**PUBLIC INTEREST REVIEW FOR GROUND WATER APPLICATIONS**

TO: Water Rights Section Date 12/28/2010  
 FROM: Ground Water/Hydrology Section K. Lite  
Reviewer's Name  
 SUBJECT: Application G- 17338 Supersedes review of \_\_\_\_\_  
Date of Review(s)

**A. GENERAL INFORMATION:** Applicant's Name: Facebook Inc. County: Crook

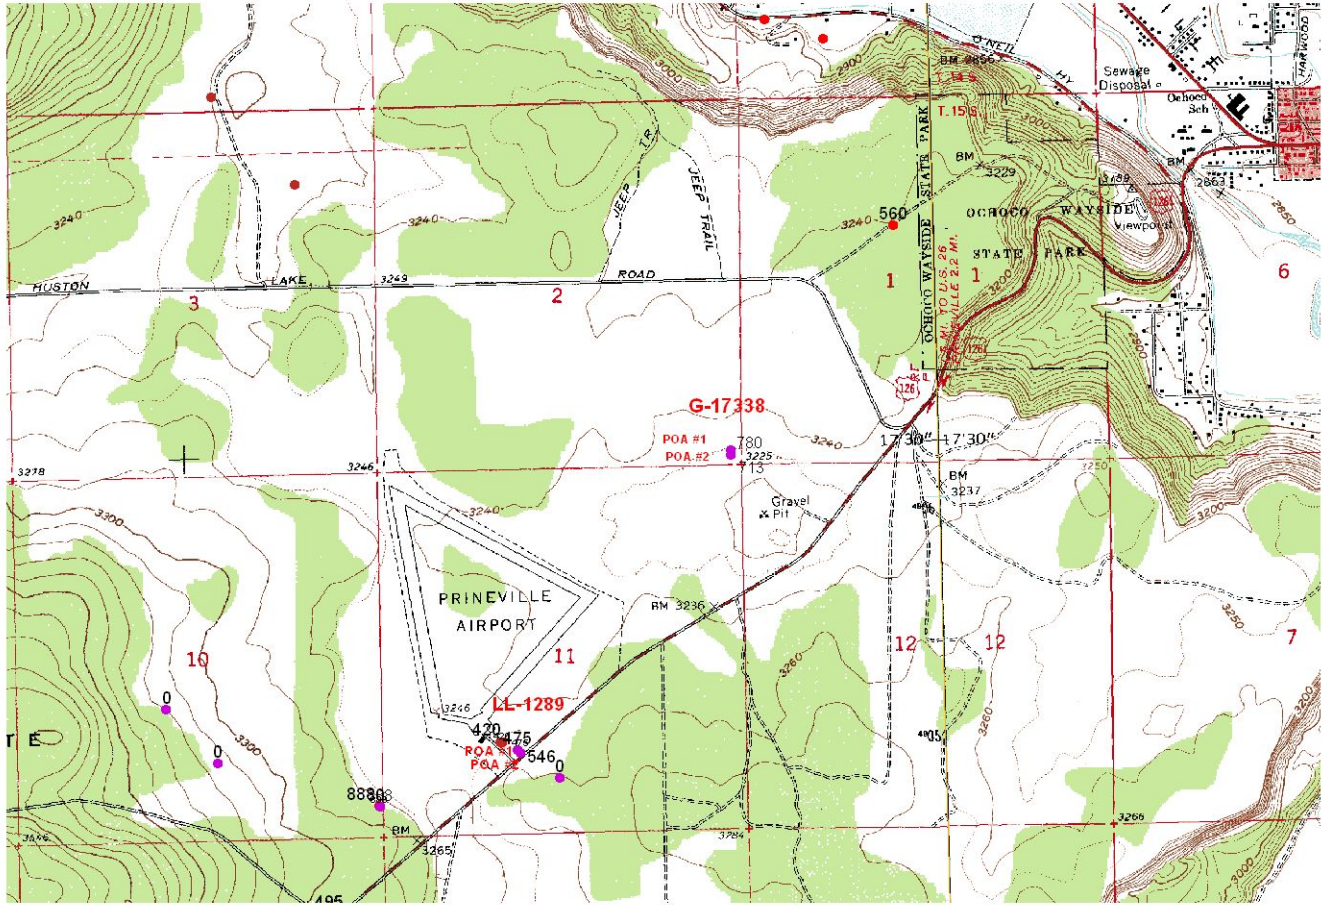
B3. **Ground water availability remarks:** THE NEAREST RELEVANT STATE OBSERVATION WELL IS OBS WELL 1314 (CROO 1954), LOCATED ABOUT 5.1 MILES TO THE SOUTHWEST. IT HAS BEEN MONITORED SINCE 1994. THE LONG-TERM TREND SHOWS THE WATER LEVEL HAS BEEN STEADILY DECLINING. SINCE 1994 THE WATER LEVEL HAS DROPPED ABOUT 62 FEET. THE DECLINE AT THE STATE OBSERVATION WELL IS A RESULT OF DECREASED RECHARGE AND LIKELY INCREASED GROUND-WATER PUMPING IN THE AREA.
